DEVELOPMENT REVIEW BOARD
SUPPLEMENTAL SUBMITTAL

PROJECT NO. PR-2019-00204
Application No. SD-2022-00020

Re: Preliminary Plat Review for Proposed Subdivision of Tracts 12-B-1-A and 12-B-1-B of El Rancho Grande I

Comments from Preliminary Plat hearing on March 9th under project number PR-2019-002042 SD-2022-00020 are addressed below:

Detail A
n.t.s.

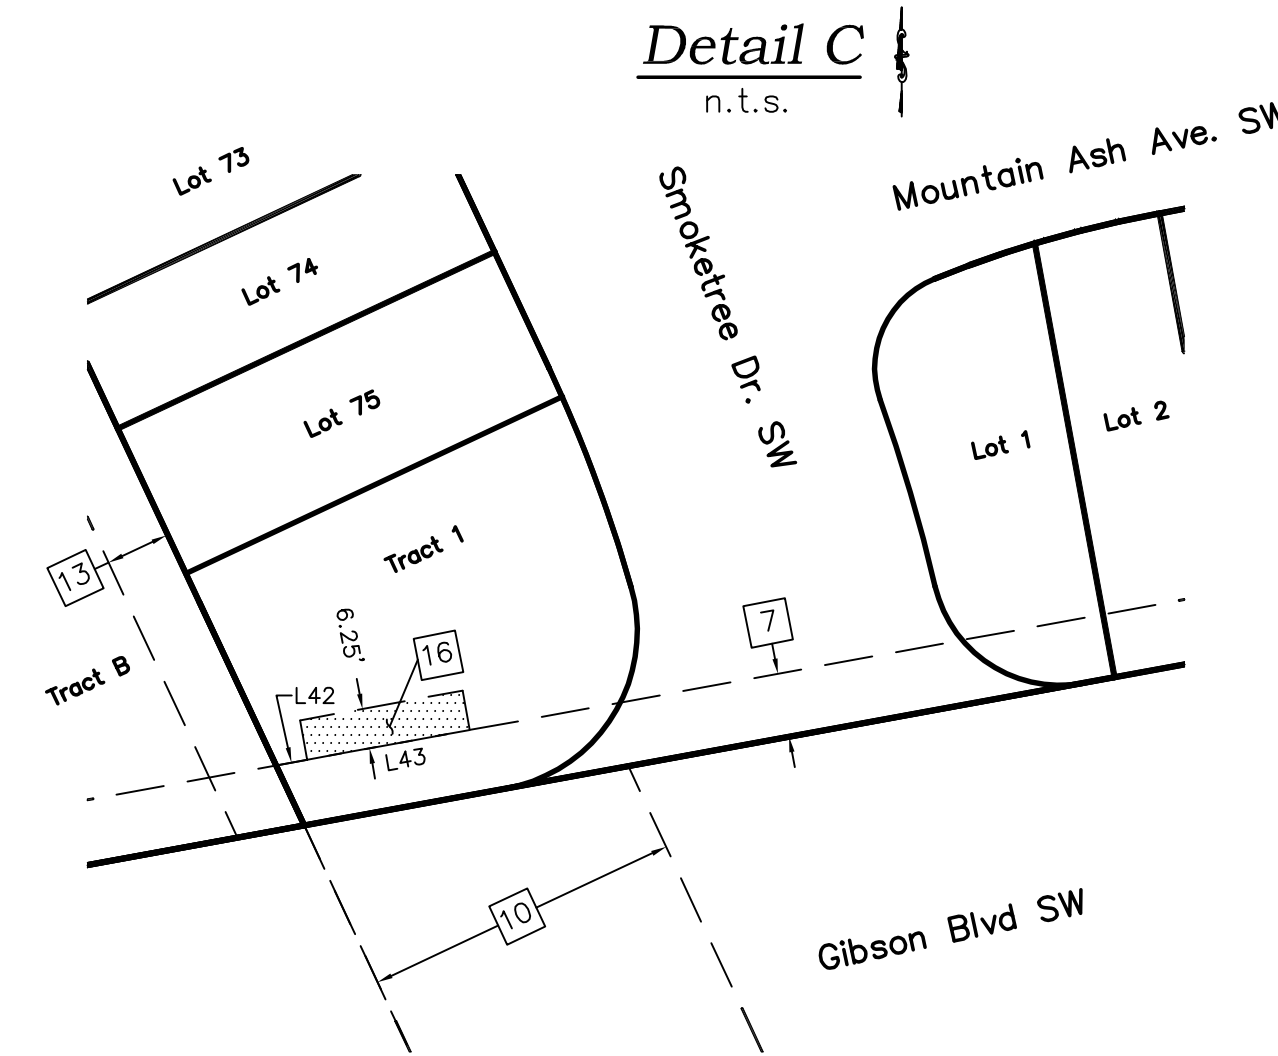
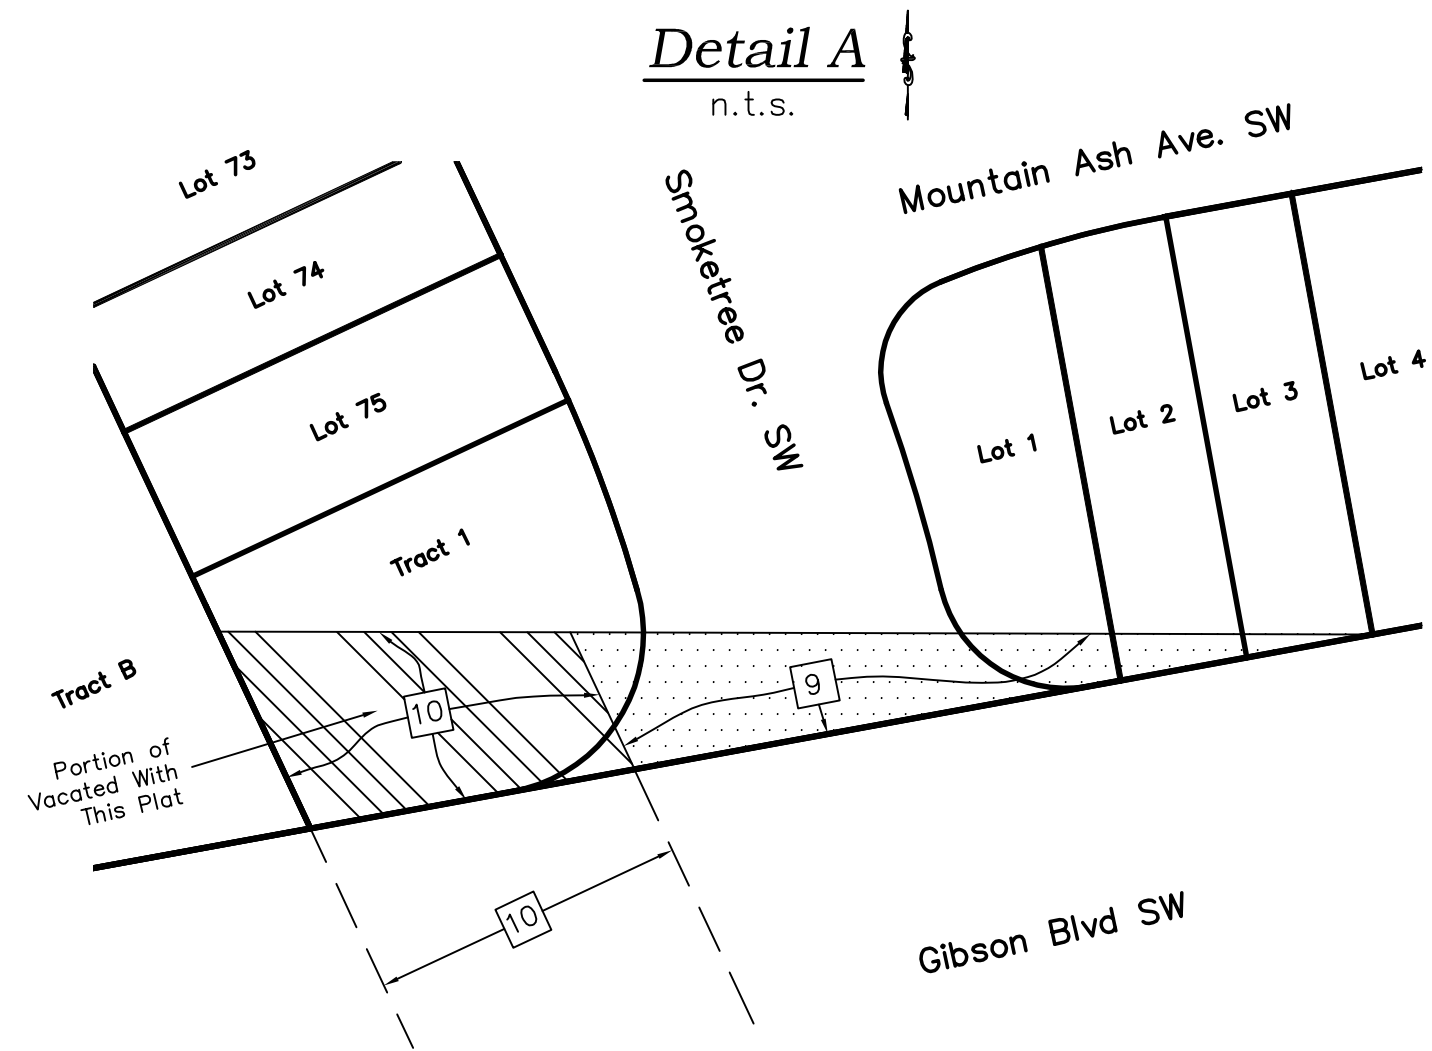
1. Easement #9 (existing 20' permanent waterline easement) is shown to be located within Smoketree Dr. in the proposed right-of-way. Shouldn't this be vacated with this plating action, assuming 811 line spots have been confirmed not to have any infrastructure?
2. Easement #10 (existing permanent access road and waterline easement) extends into proposed Tract 1. Shouldn't this be vacated with this plating action, assuming 811 line spots have been confirmed not to have any infrastructure?

Easement 9 and portion of easement 10 are now vacated as shown on preliminary plat. 811 spotting showed these areas to not be occupied.

SOMBRA DEL OESTE
STREET SECTIONS

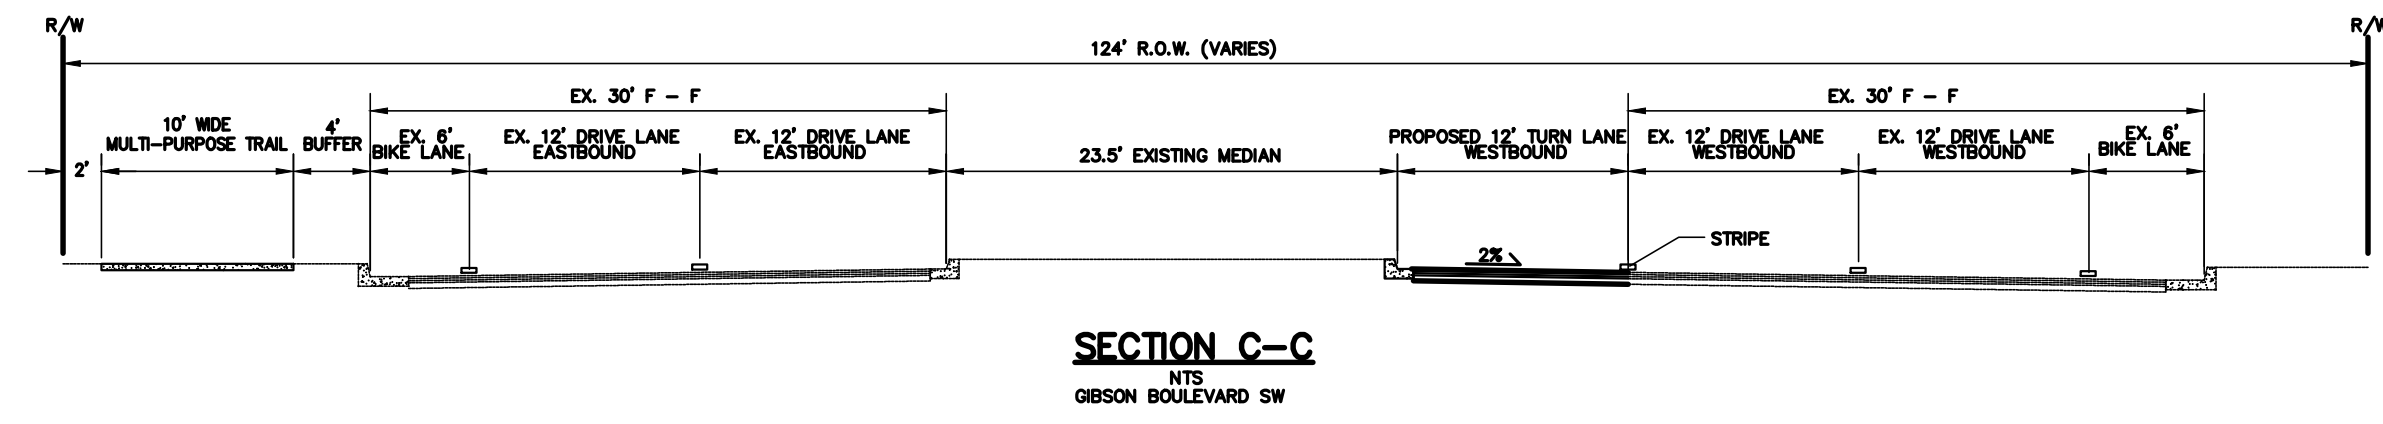
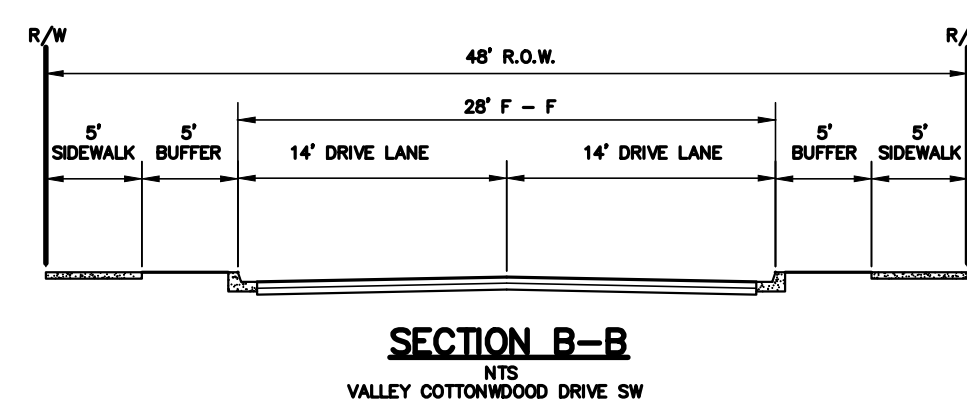
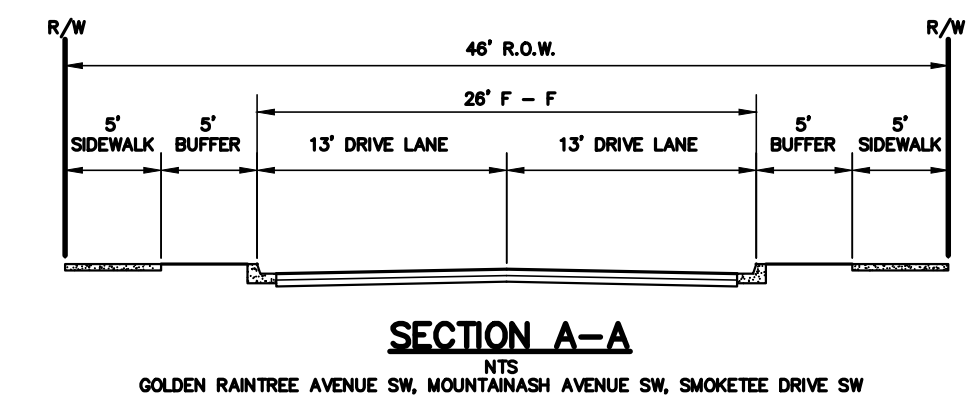
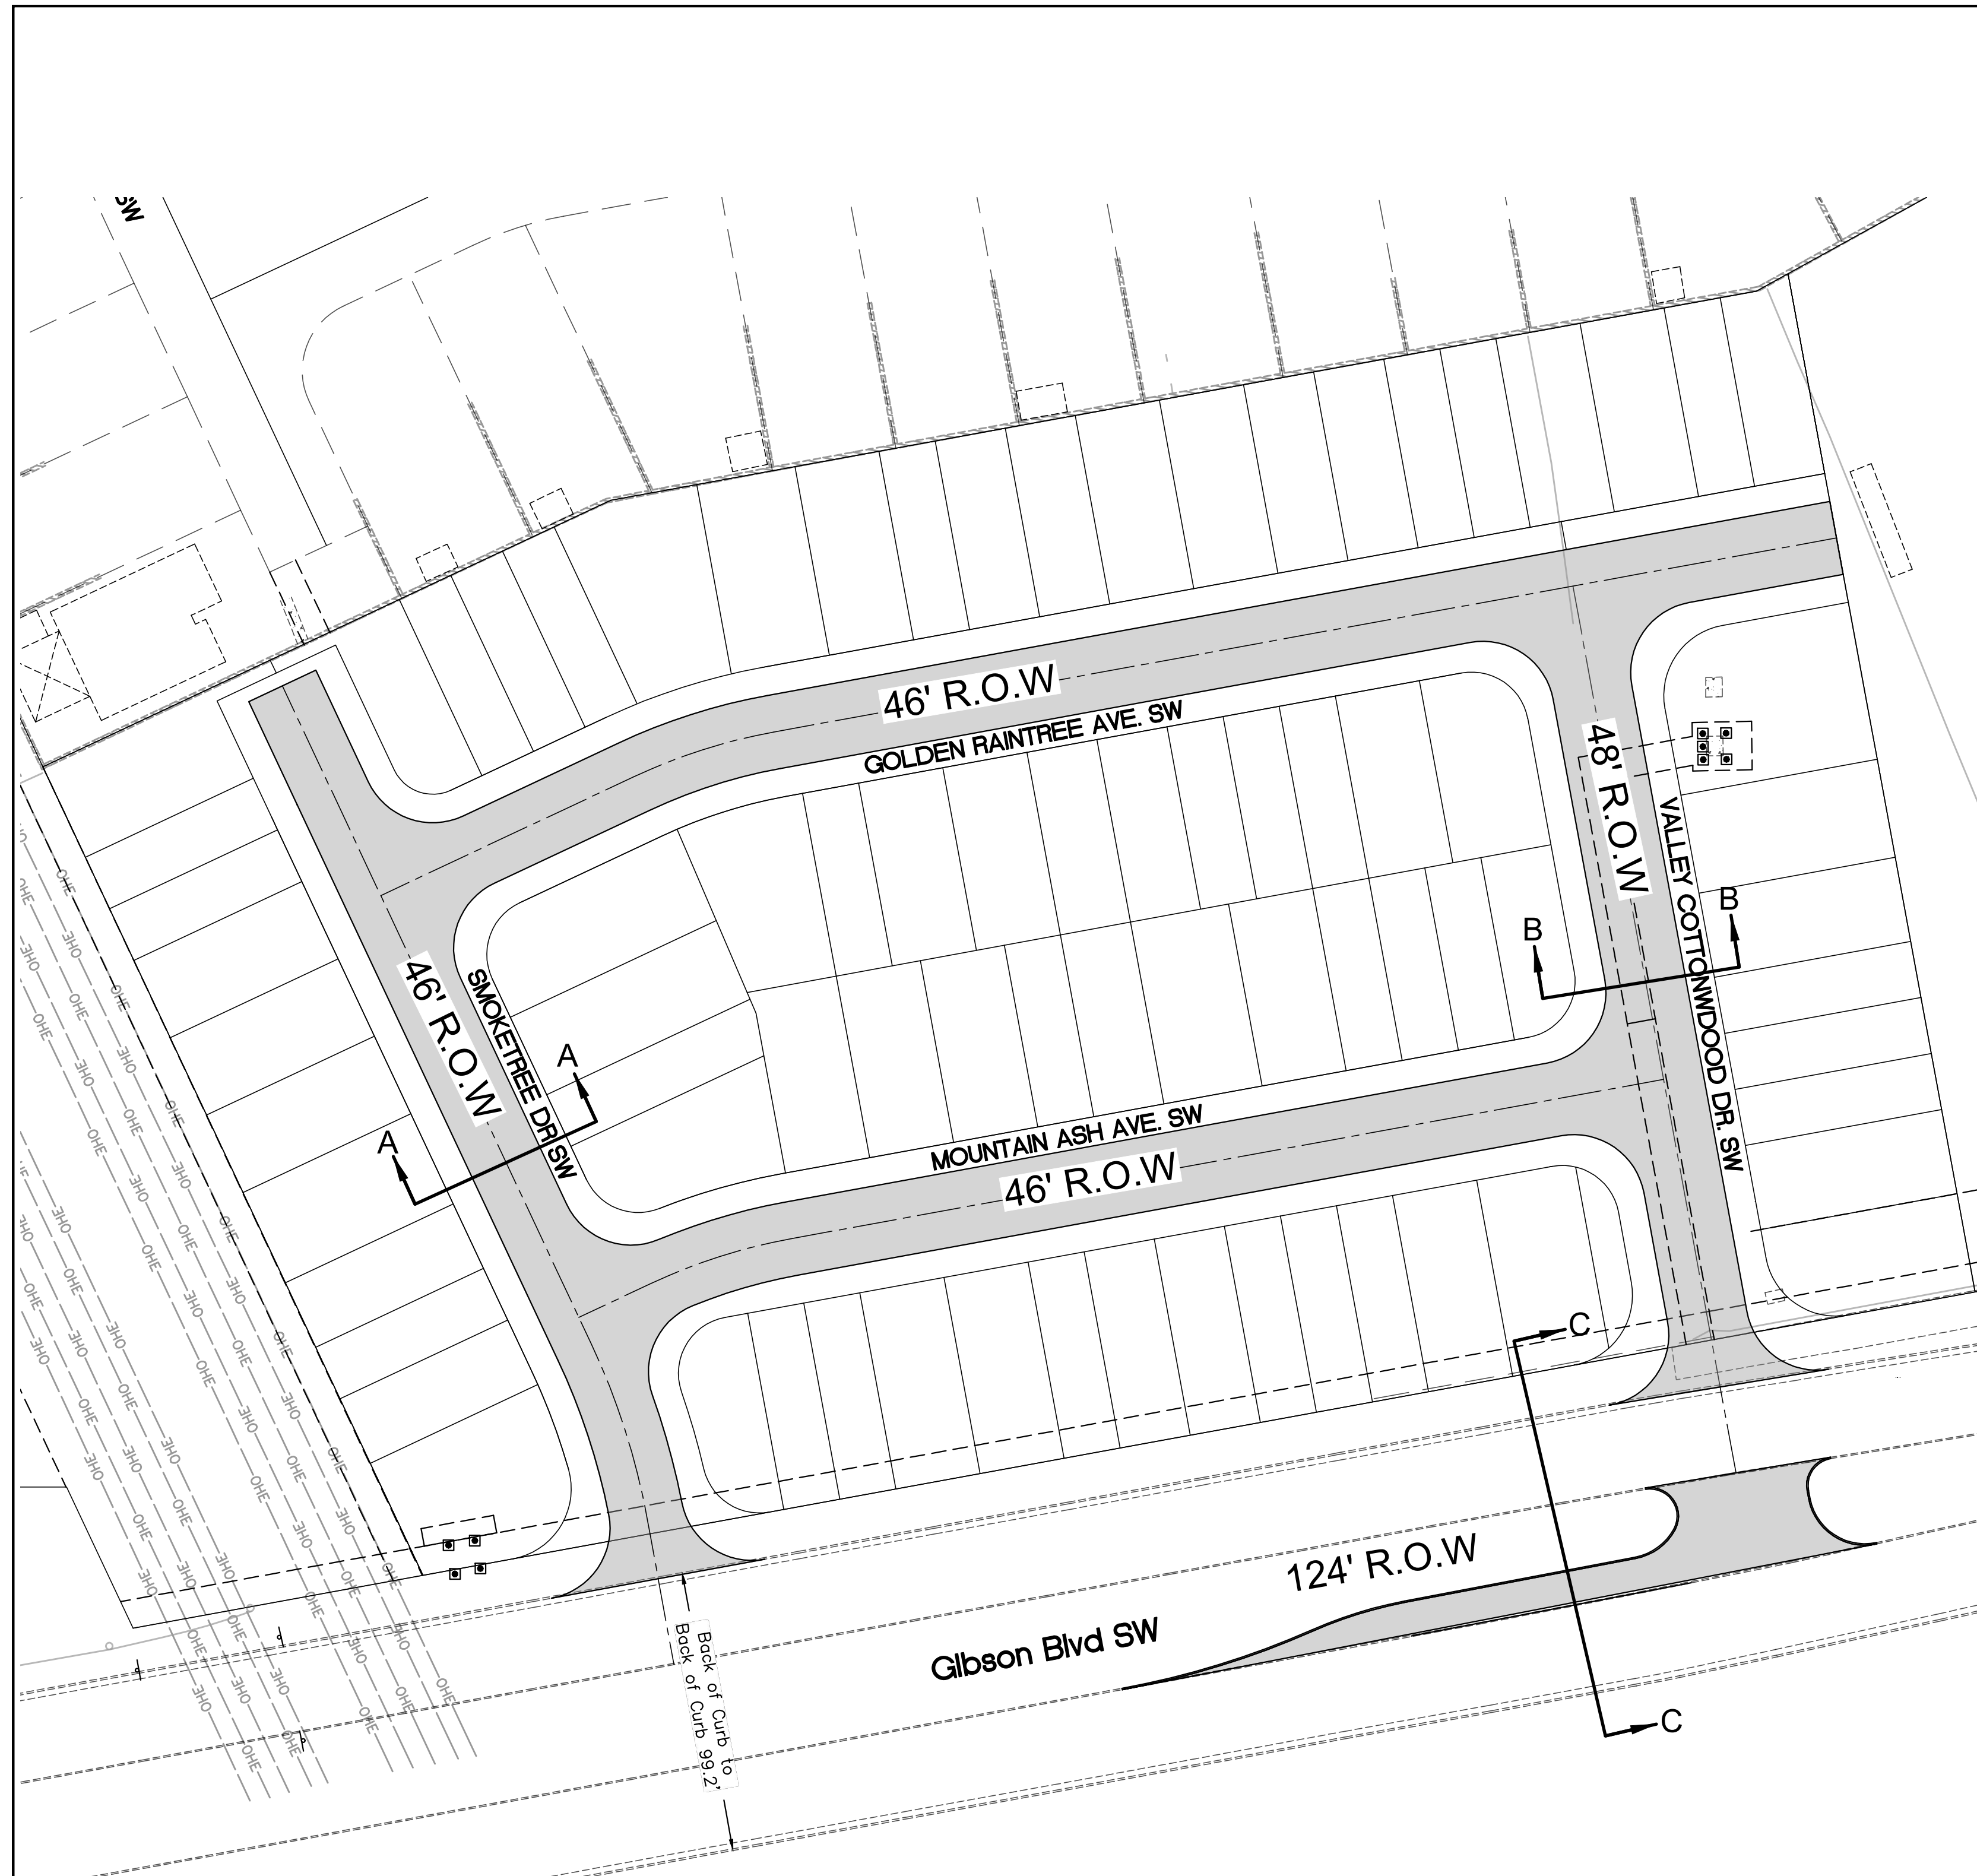
2. The infrastructure list should indicate 5-foot sidewalk for all roads per the cross-section details. For further specification, include a note to refer to deferred sidewalk per the Sidewalk Exhibit.

Noted, infrastructure list has been modified to include sidewalk or is covered under deferral of sidewalk request.
